Project Name: 9101 Highland
 Description: Revised preliminary site plan approval recommendation
 Date on Agenda this packet pertains to: January 16, 2025

RE: 9101 Highland Road-Proposed Commercial Development- Preliminary Site Plan Review – 3rd Review

**Preliminary Site Plan / Special Land Use Review
for
White Lake Charter Township, Michigan**

Applicant:	Affinity 10 Investment, LLC
Project Name:	9101 Highland Road
Plan Date:	July 24, 2024
First Revision Date:	October 17, 2024
Second Revision Date:	December 20, 2024
Location:	South side of Highland Road (M-59), West of Sunny Beach Boulevard. Parcel ID: 12-23-227-003
Action Requested:	Preliminary site plan and special land use review

C-1

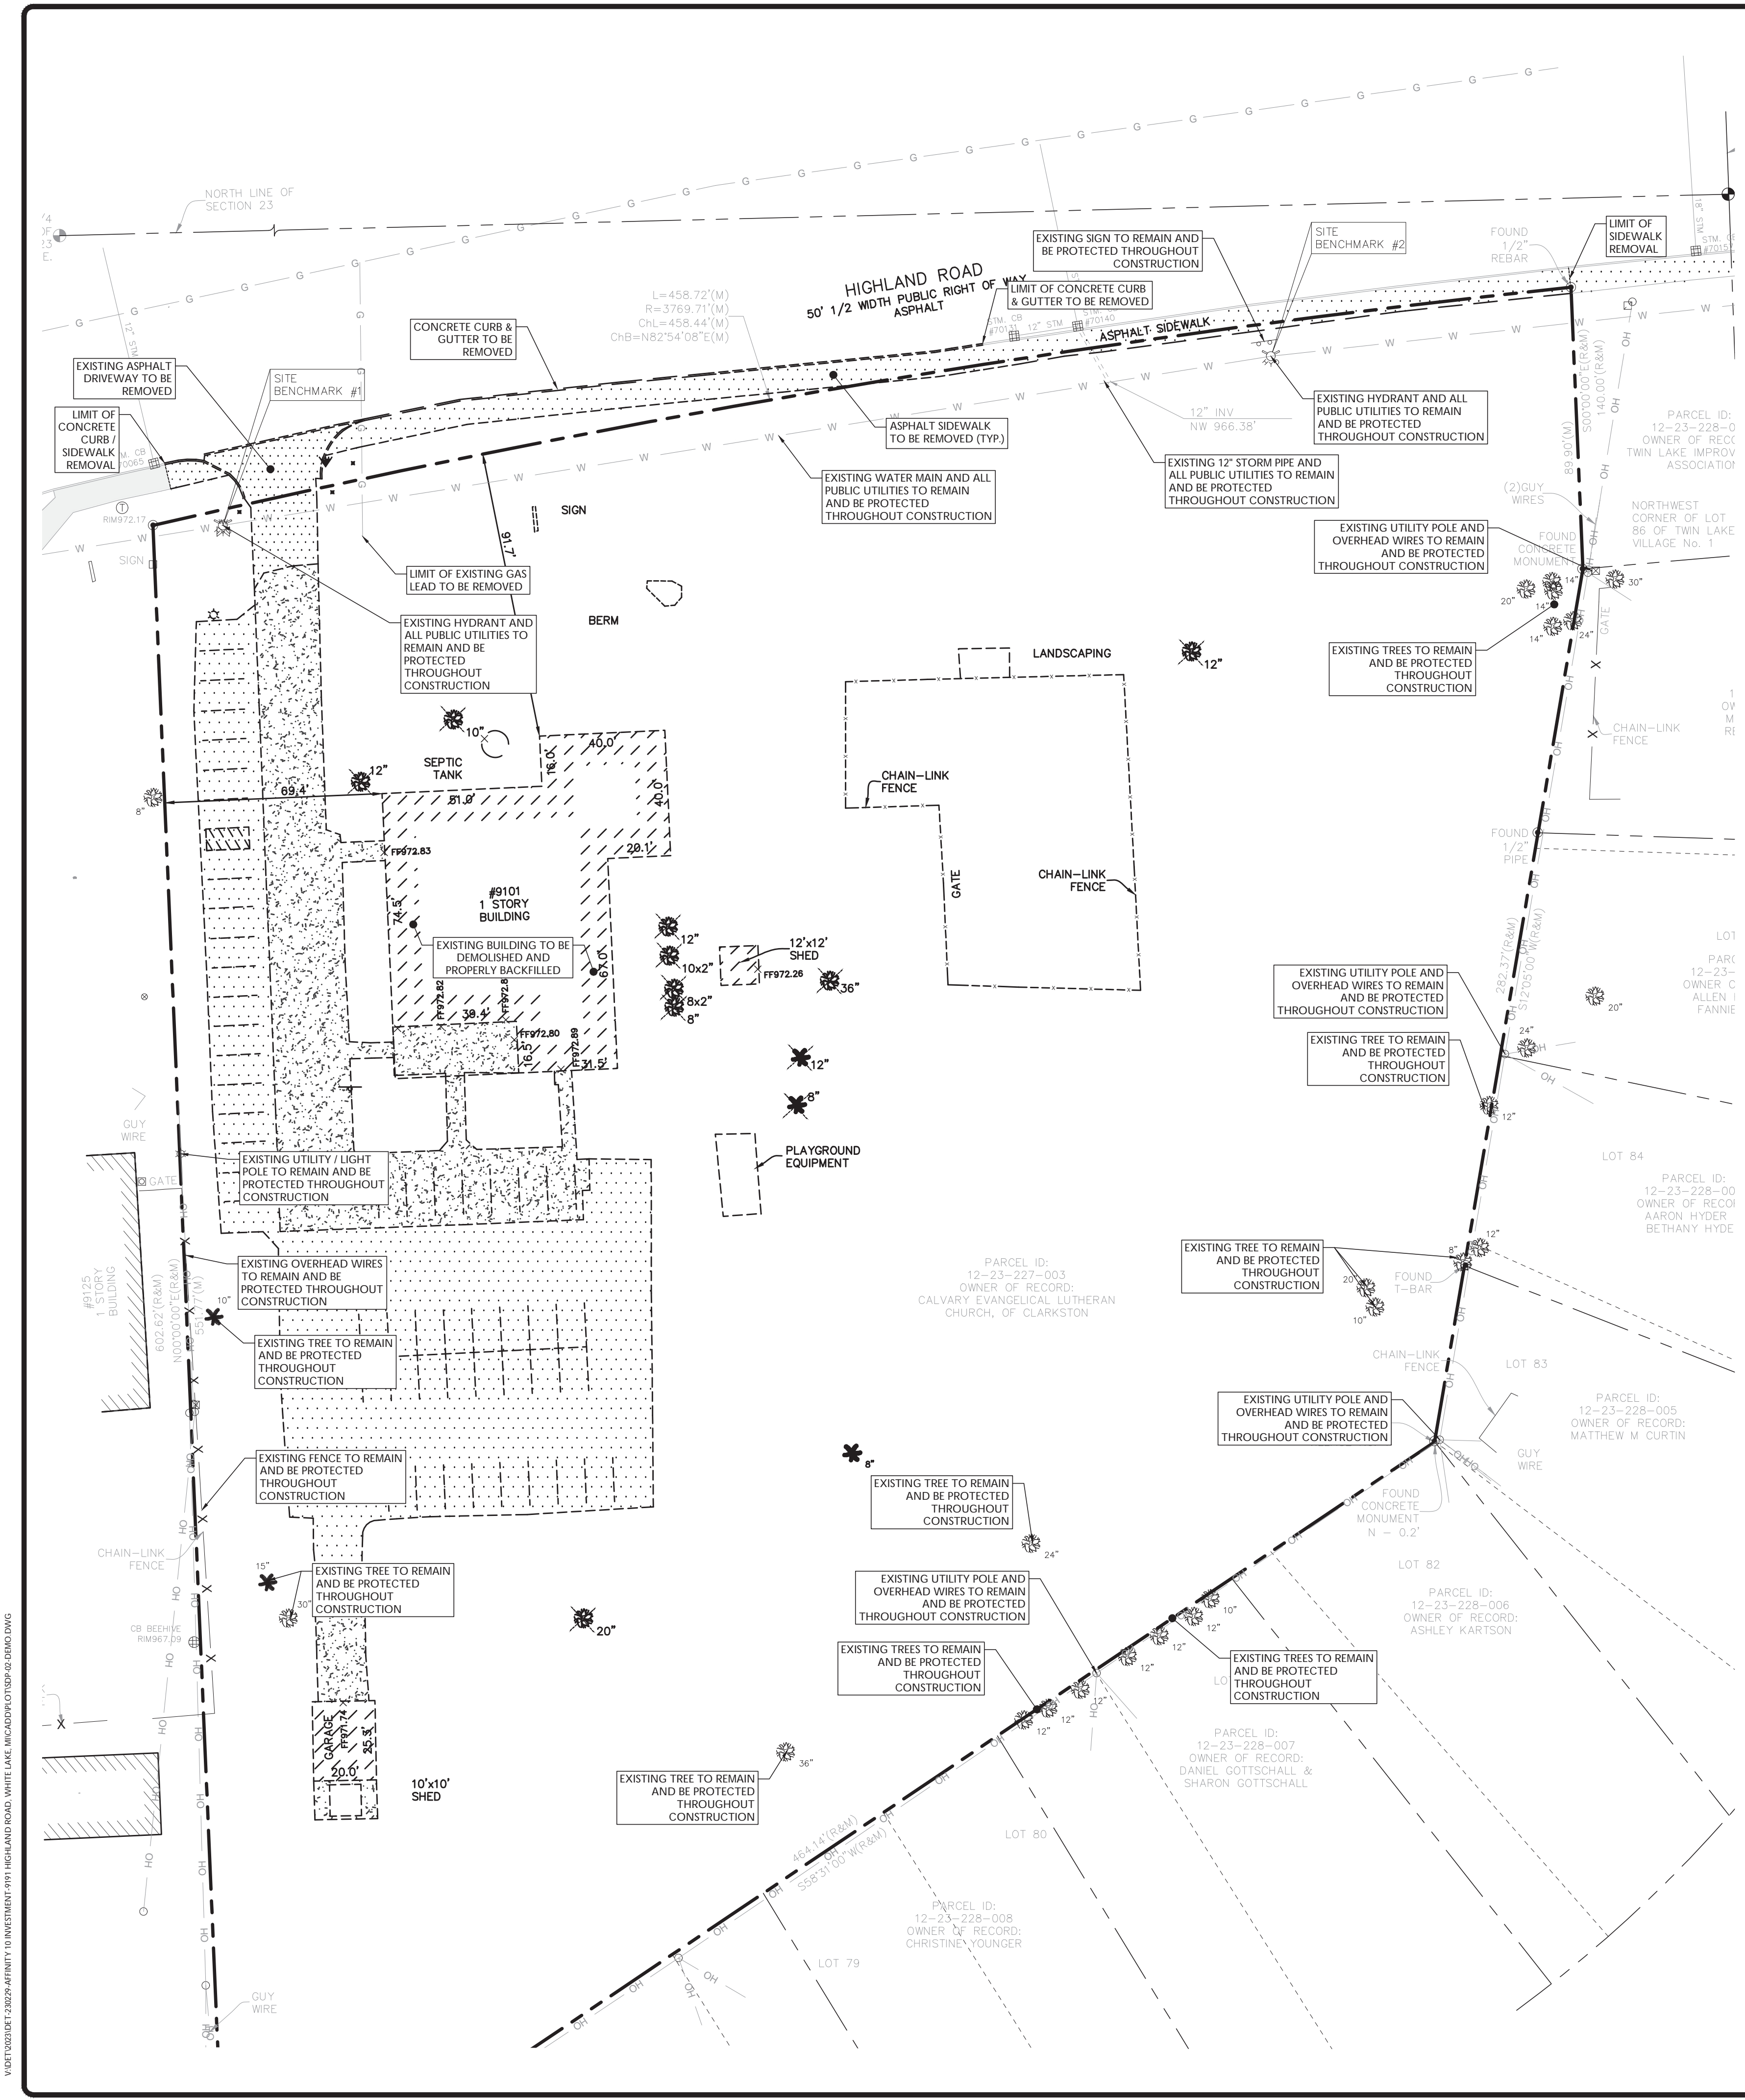
- a) *Cover sheet C-1- Provide ALTA/NSPS Land Title Survey with next submittal. **Comment addressed at the preliminary level and remains. The survey has now been provided. Please provide surveyor seal and signature on this sheet on the Final Site Plan/Final Engineering Plan.***

DRAWING: C-7

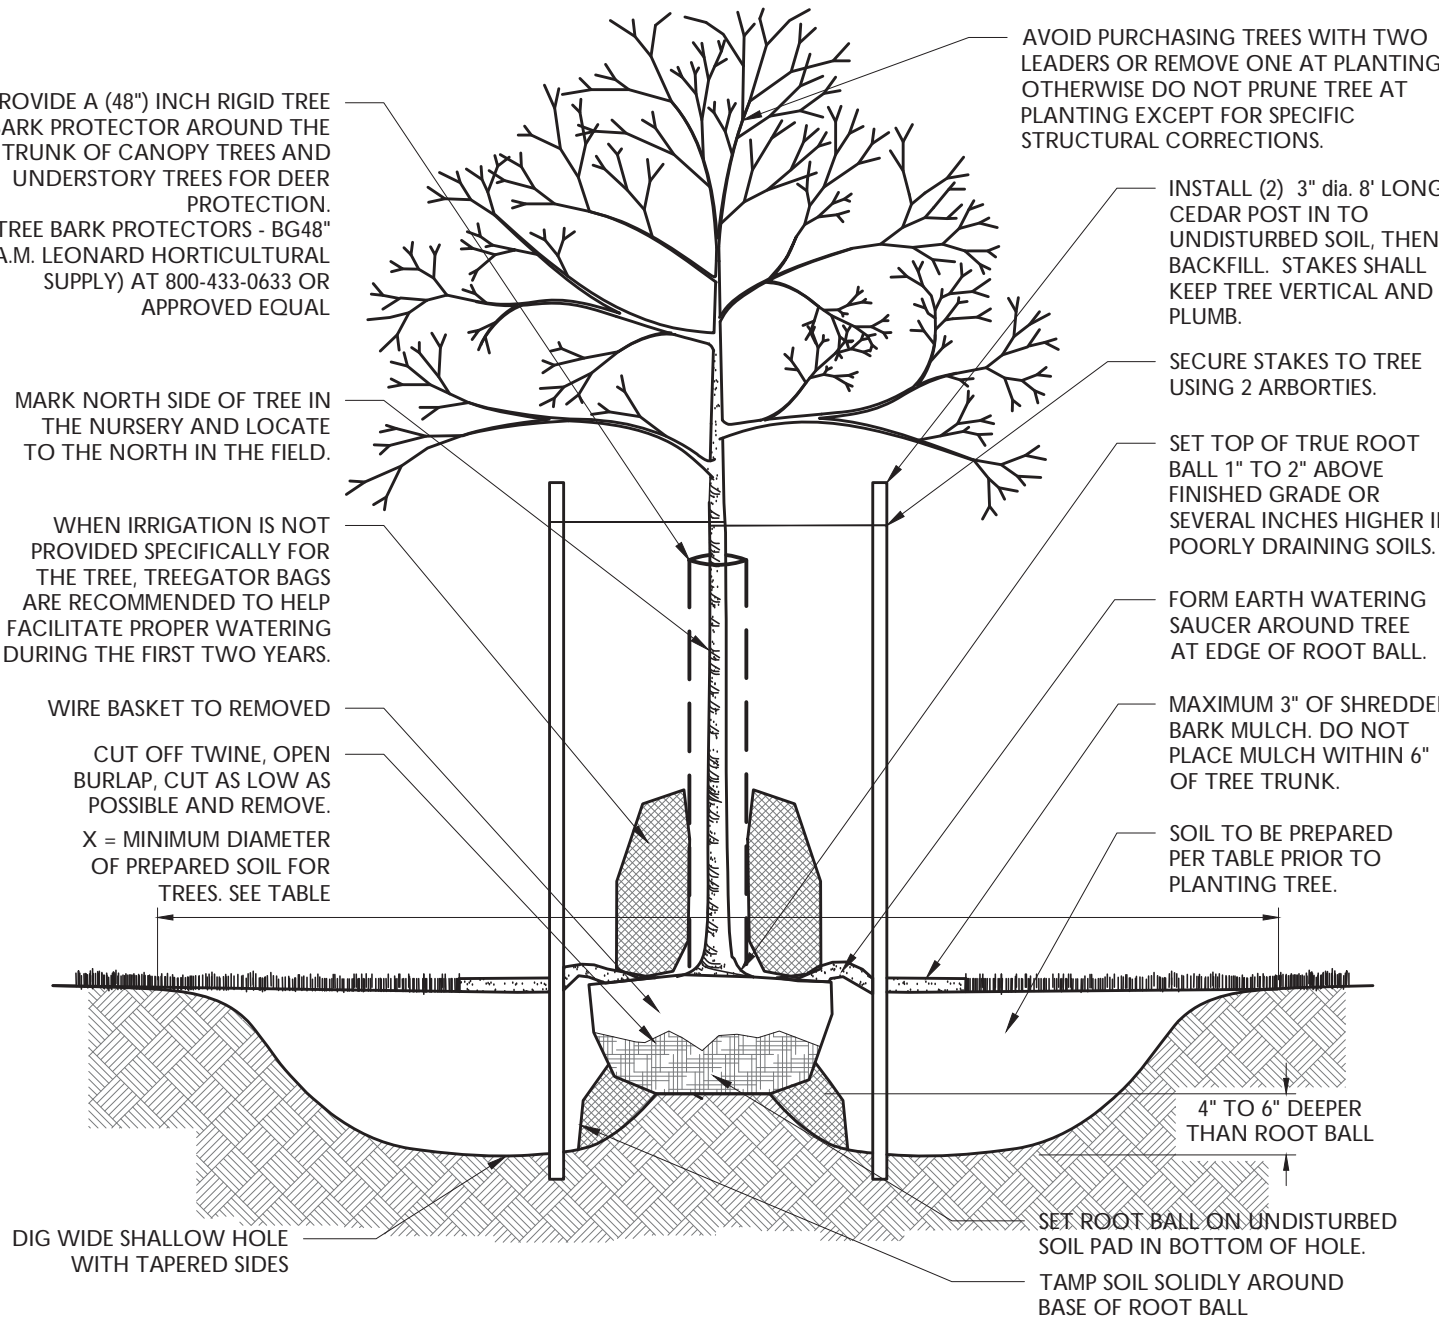
Given the site will have multiple tenants, Sheet C-7 should have a note stating that there shall be no flashing, oscillating, moving or intermittent type of lighting or illumination on the site.

Items to be Addressed: Sheet C-7 should have a note stating that there shall be no flashing, oscillating, moving or intermittent type of lighting or illumination on the site
